RE: CPV Sentinel Energy Project  
Application for Certification 07-AFC-3

- Twenty-five printed copies of the CPV Sentinel Energy Project Response to Data Requests (35, 38, 43, 50, 60, and 62 through 65)
- Fifty CDs containing the CPV Sentinel Energy Project Response to Data Requests (35, 38, 43, 50, 60, and 62 through 65)

**APPLICATION FOR CERTIFICATION  
FOR THE CPV SENTINEL ENERGY  
PROJECT  
Power Plant Licensing Case**

**FIGURE 50-4**

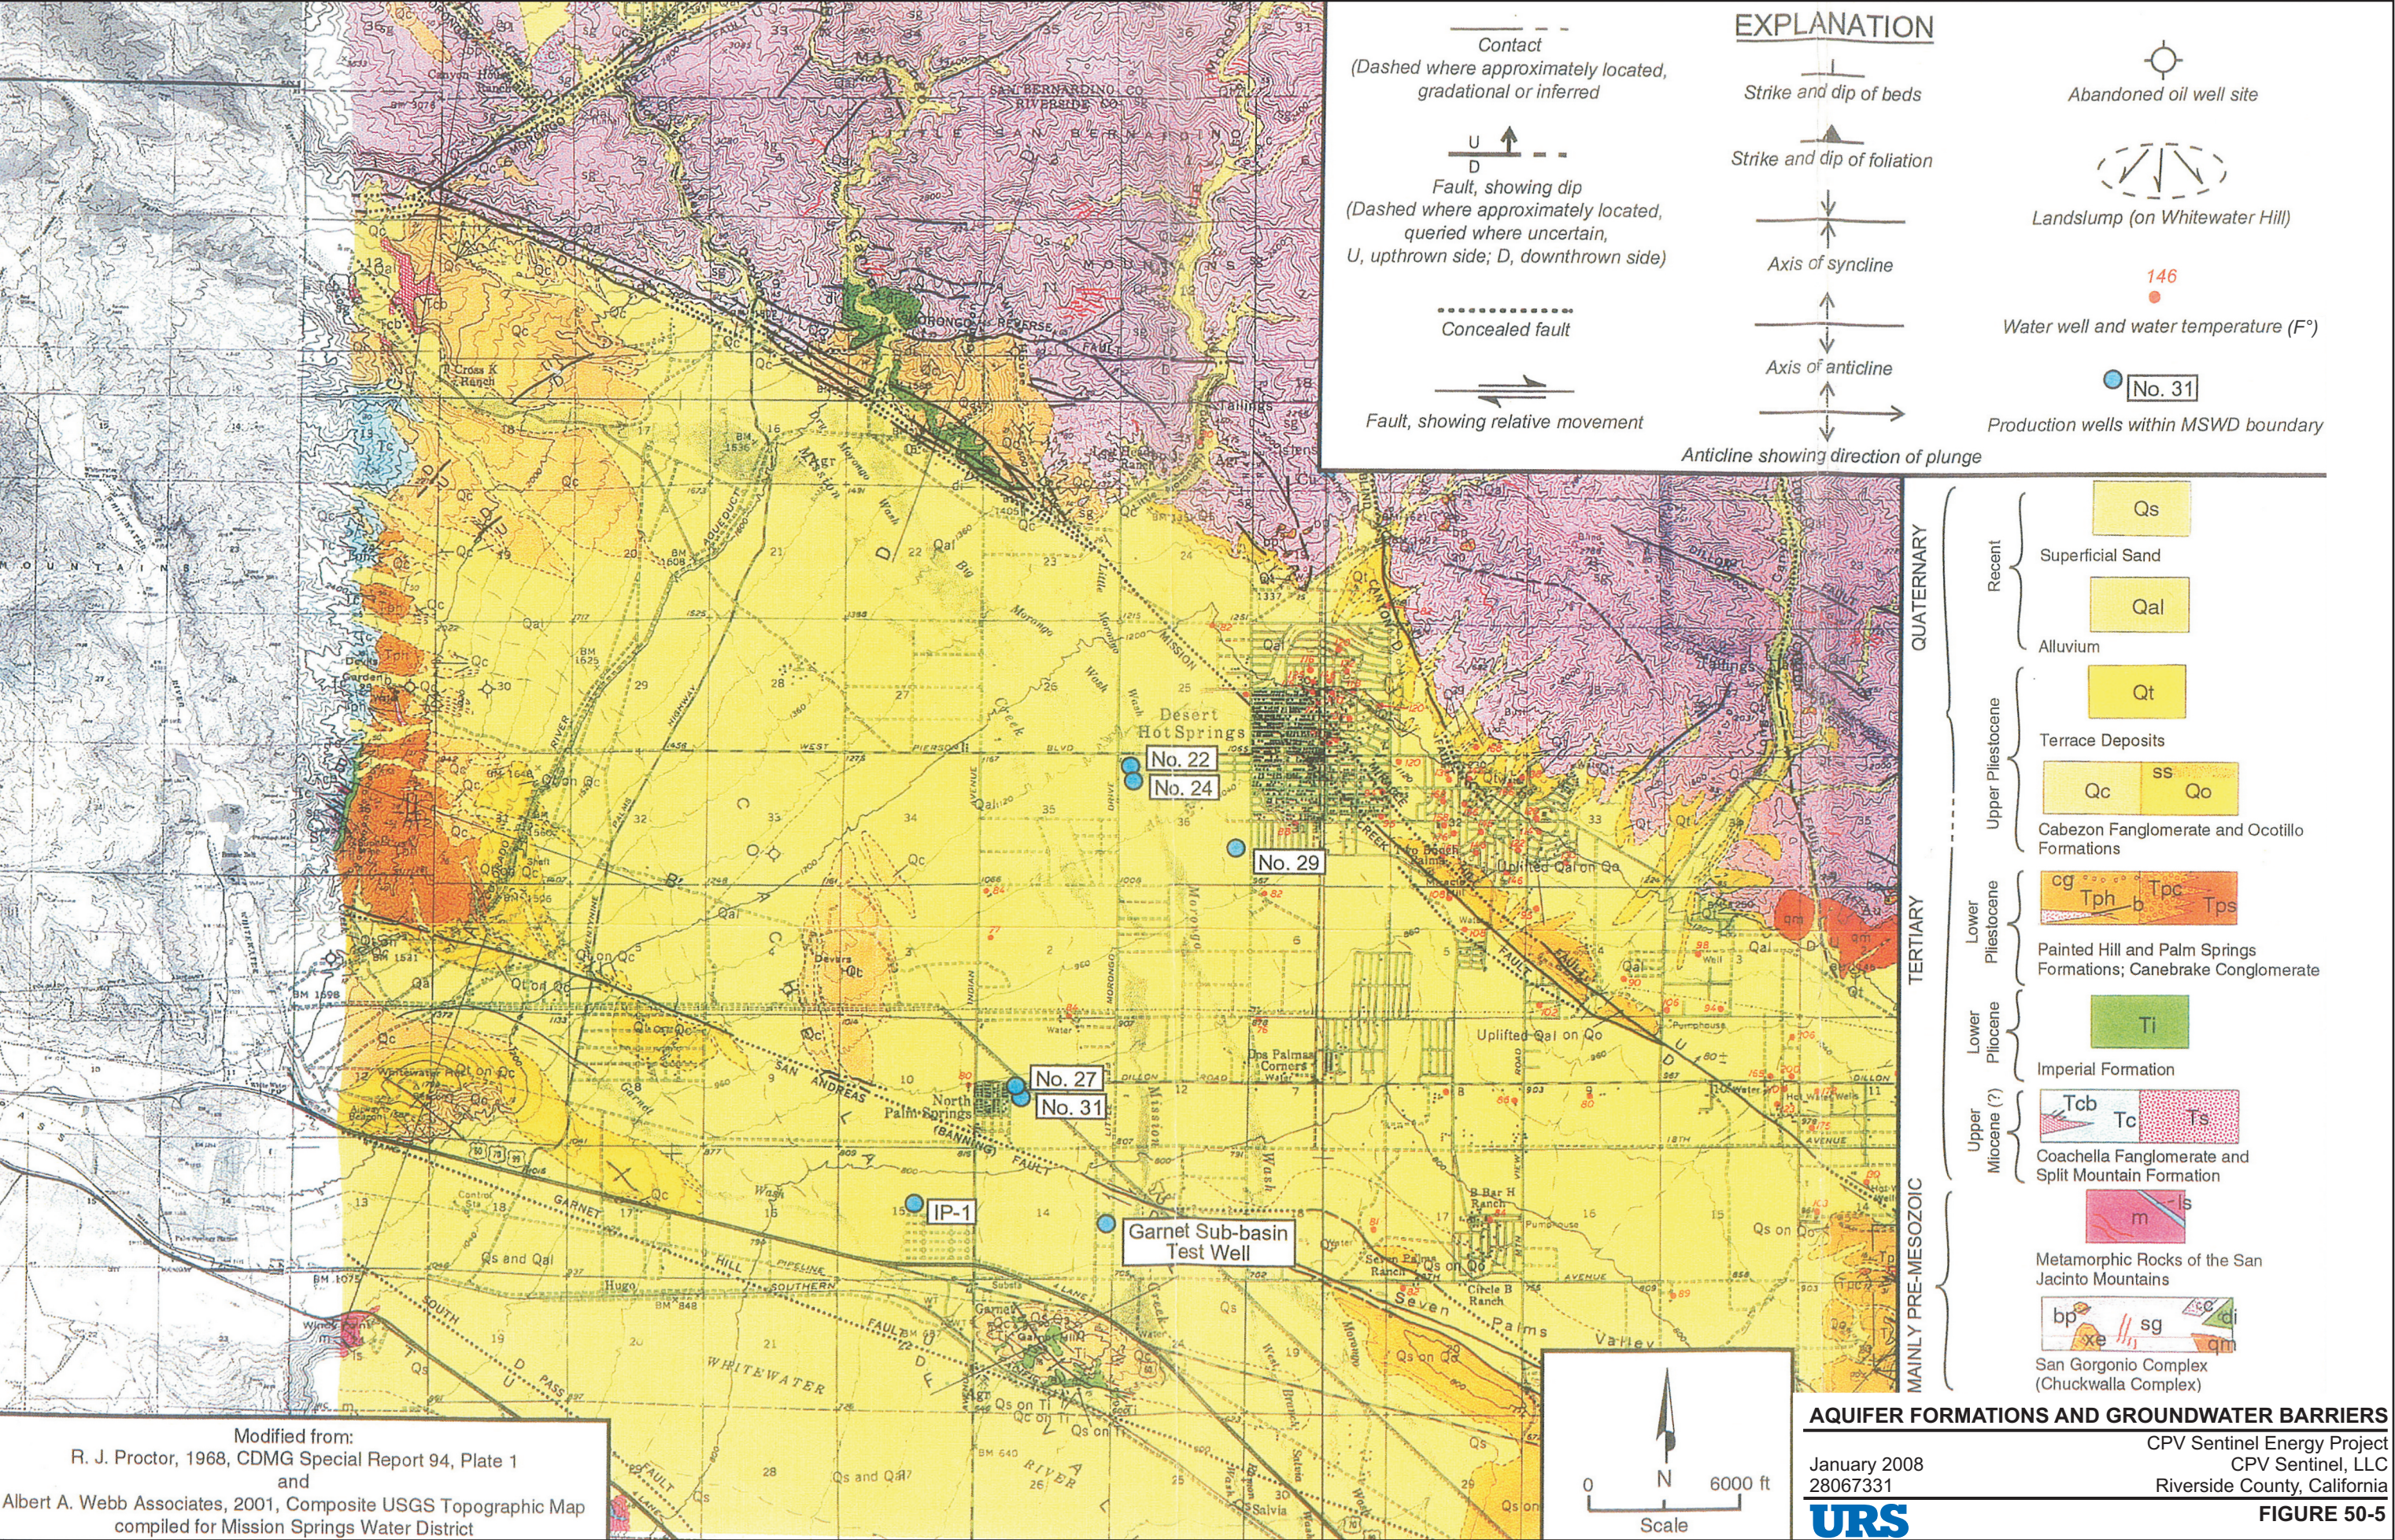
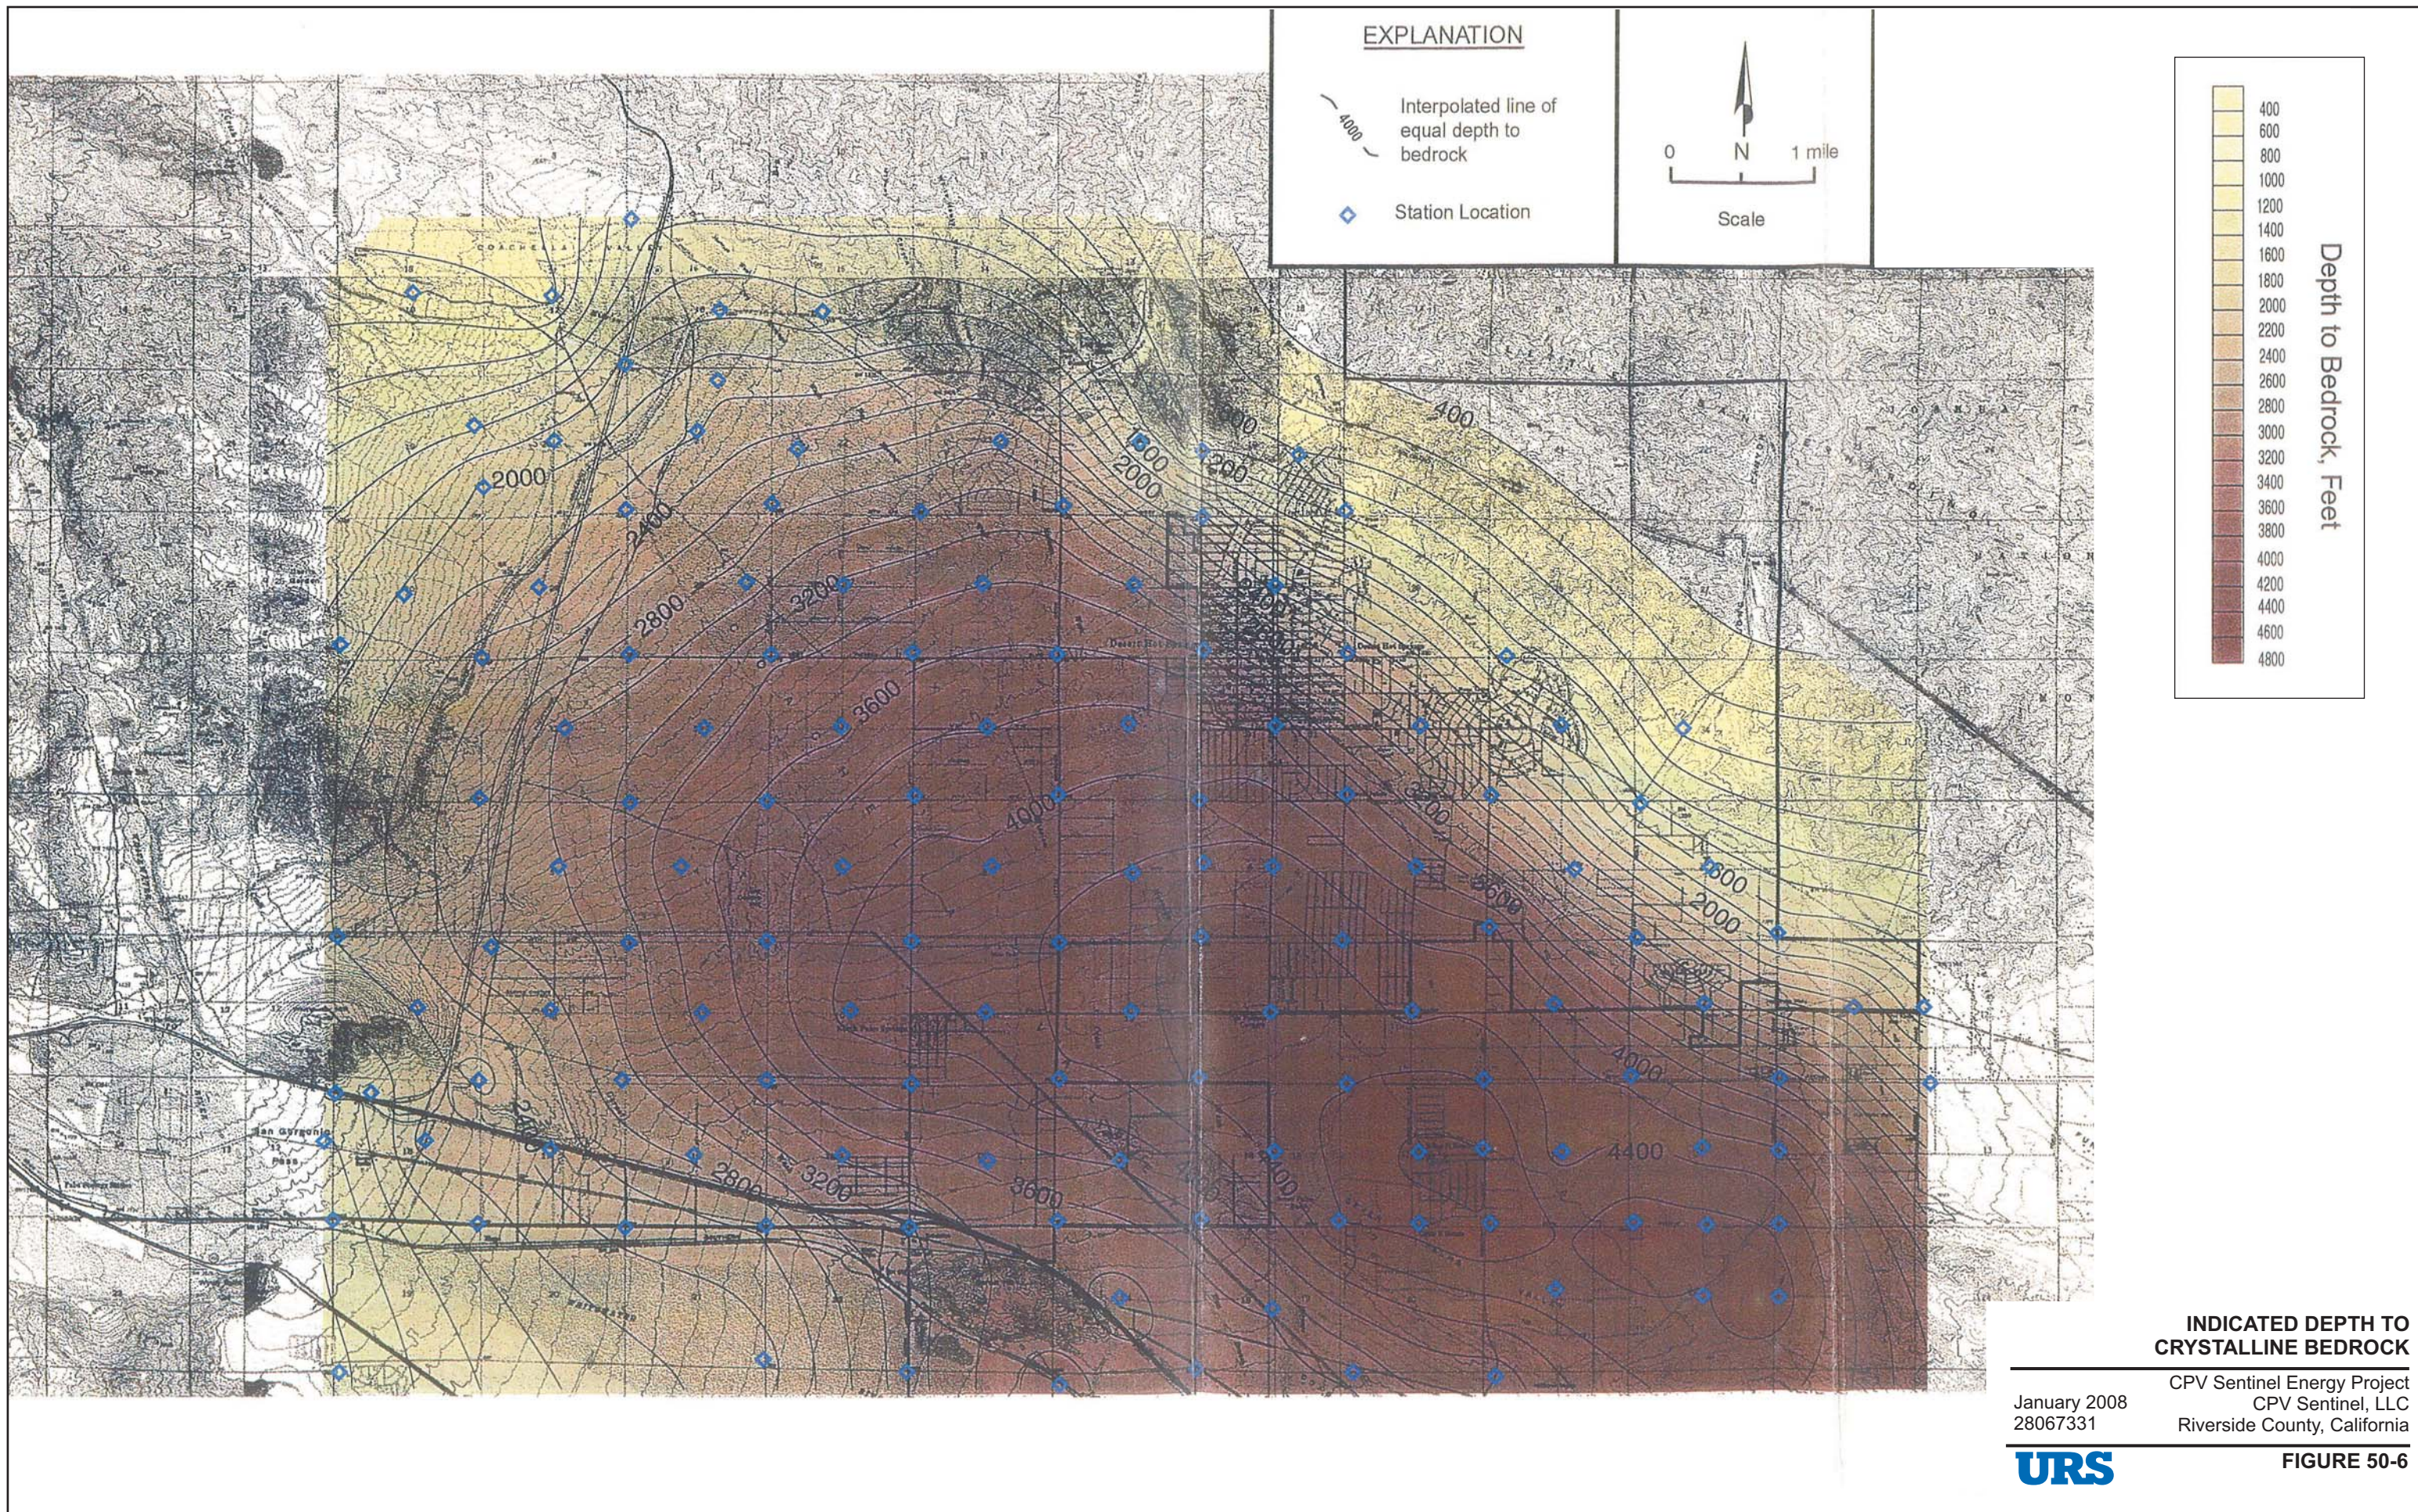
**50. Please provide a description of the site-specific hydrologic and geologic conditions of the Horton WWTP percolation site. The purpose of this request is to obtain information necessary to assess the hydrologic effect of the percolation. Please include the following information:**

- e) Figure 50-3 shows the location of the Horton WWTP. Figure 50-4 shows the five existing percolation ponds. Figure 50-5 shows hydrologic and hydrogeologic features. Figure 50-6 shows depth to crystalline bedrock within the Mission Springs Subbasin, which represents the approximate base of the aquifer.

- g) See previously submitted responses. No additional information.
- h) See previously submitted responses. No additional information.
- i) The previously submitted responses reported that the acreage of the existing Horton WWTP percolation ponds is approximately 5 acres, based on aerial photos. According to Earth Tech, Inc, (2007), the five existing percolation ponds have an infiltration area of approximately 4 acres (see Figure 50-4).
